Modification Notice - Regulation 22

Interest Holder	Santos QNT Pty Ltd		EMP Title	McArthur Basin Drilling Program NT Exploration Permit (EP) 161		Unique EMP ID No.	STO2-7	Change/Mod No.	3	Date	16/09/2021
Brief Description	The modification to the activity is that the lateral sections of horizontal wells at Tanumbirini will not be separated by 50mTVD and are planned to target the same shale interval. The Tanumbirini 3H Well Plan Summary, Attachment 1, has been updated accordingly, review by the Department of Industry Tourism and Trade and accepted.										
Geospatial Files Included?											
Does the proposed change result in a new, or increased, potential or actual environmental impact or risk?	If an INCREASE in an existing potential or actual environmental impact or risk is it provided for in the approved EMP?	Does the proposed change require additional mitigation measures to be included?	Has additional stakeholder engagement been conducted?	Does it require additional environmental performance standards and measurement criteria?	Does it affect compliance with Sacred Site Authority Certificates?	Does it affect current rehabilitation, weed, fire, wastewater, erosion and sediment

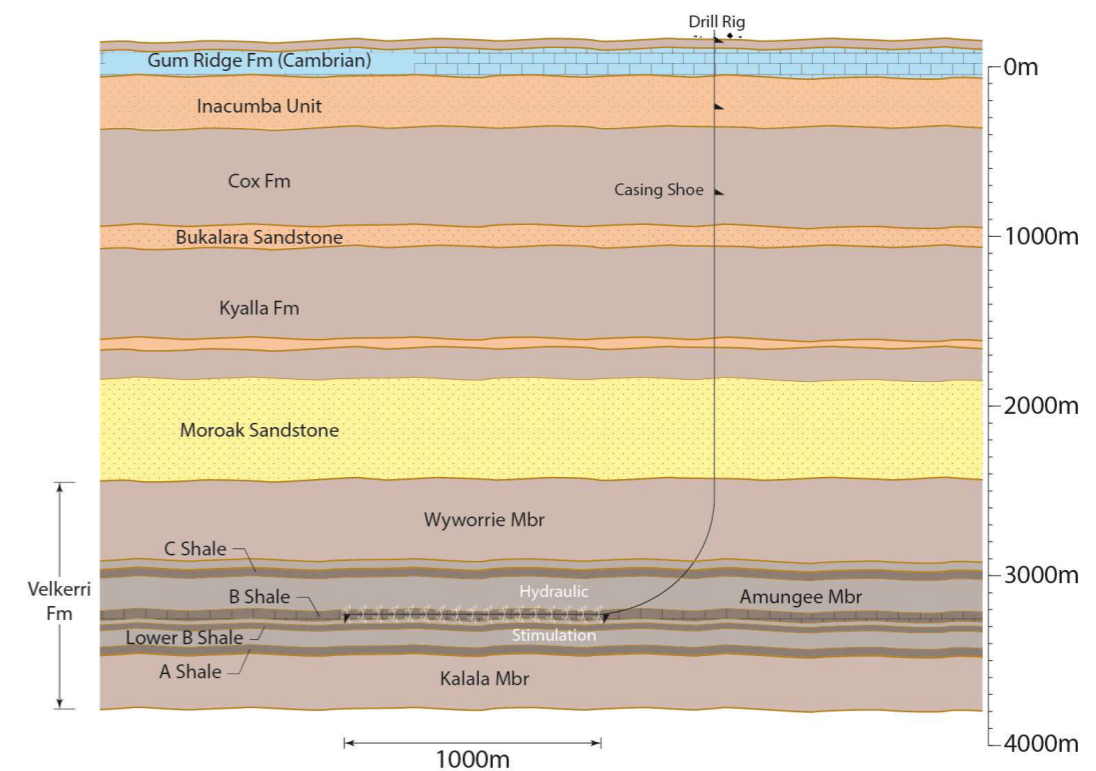
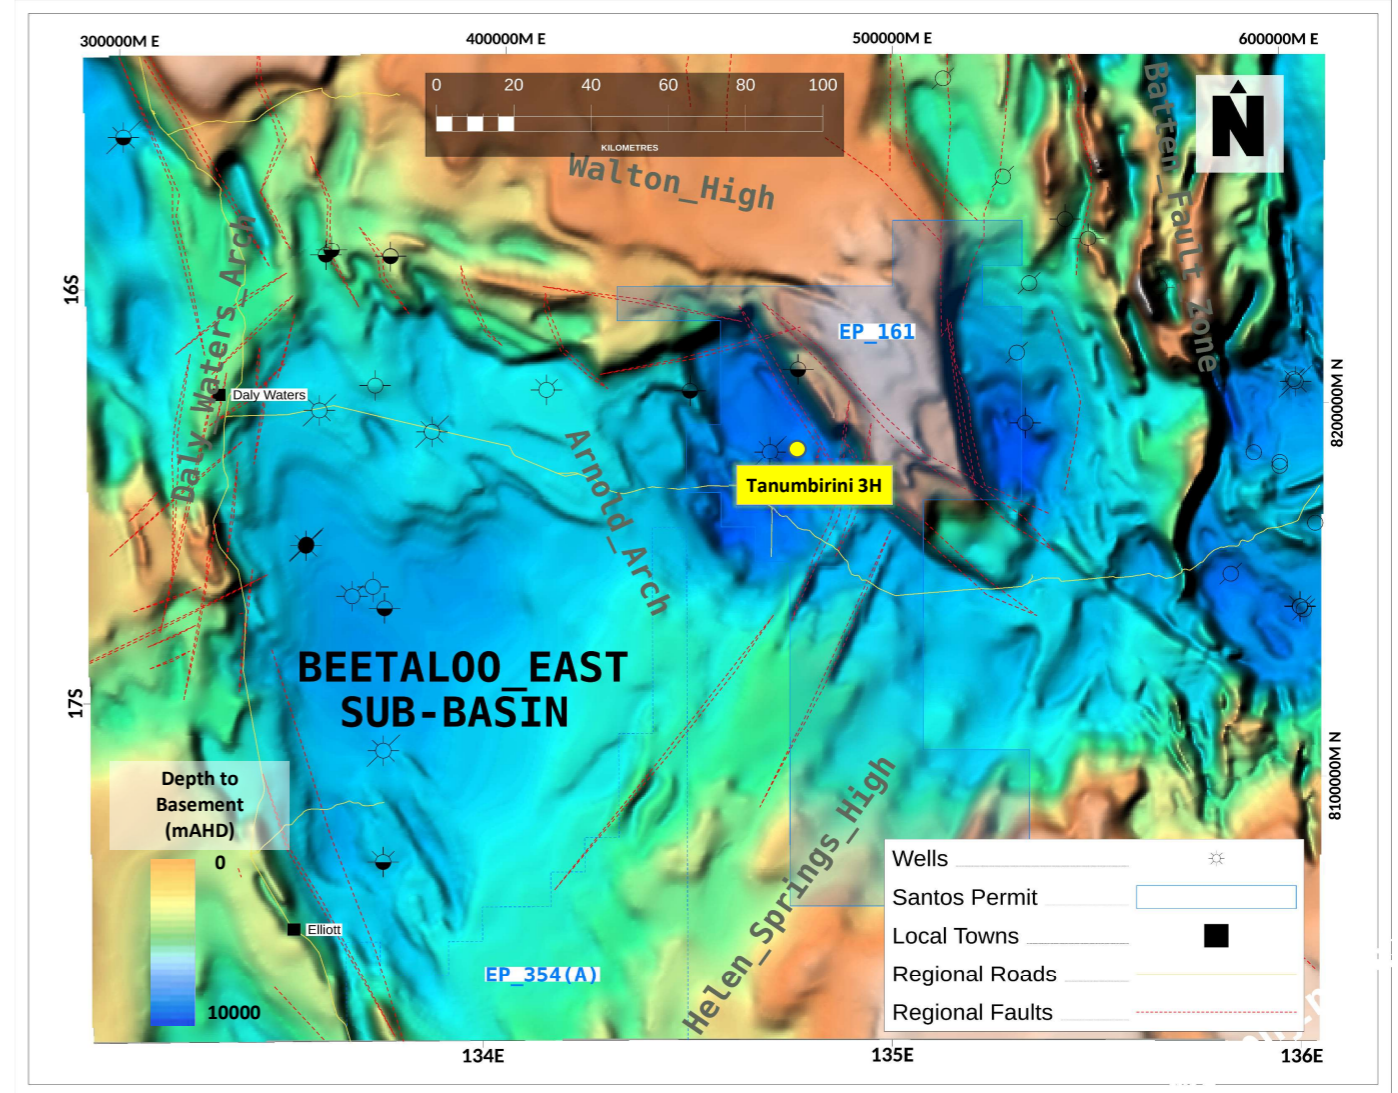
No	N/A	No	No	No	No	No	No	Yes			
Current EMP Text					Amended EMP Text						
See section 3.4.1.2 second paragraph The proposed horizontal wells have been planned to be approximately 10m apart at surface i.e. wellhead to wellhead, and the lateral sections planned to be 500m apart (Figure 3-10). The horizontals will target separate shale intervals and be vertically separated with a minimum spacing of approximately 50mTVD. After being completed with casing/tubing, the wells will also be monitored with					Replace the second paragraph in section 3.4.1.2 with the text highlighted in grey below. This sentence has been removed "The horizontals will target separate shale intervals and be vertically separated with a minimum spacing of approximately 50mTVD." The proposed horizontal wells have been planned to be approximately 10m apart at surface i.e. wellhead to wellhead, and the lateral sections

planned to be 500m apart (Figure 3-10). After being completed with casing/tubing, the wells will also be monitored with pressure gauges to detect communication during operations. The horizontal wells will be geosteered to remain in the optimum zone of the selected A, B, Lower B or C Shale intervals using real-time LWD tools. Tanumbirini-1 source rock analysis for core and cutting samples have been used to confirm TOC and calibrate petrophysical models for future data acquisition and indicates that the proposed Tanumbirini horizontal exploration wells should intersect highly mature Velkerri shale intervals with an expected dry gas composition i.e. primarily methane. The horizontal wells are currently planned to reach a total depth of 5,900 mMD/3,500 mTVD.
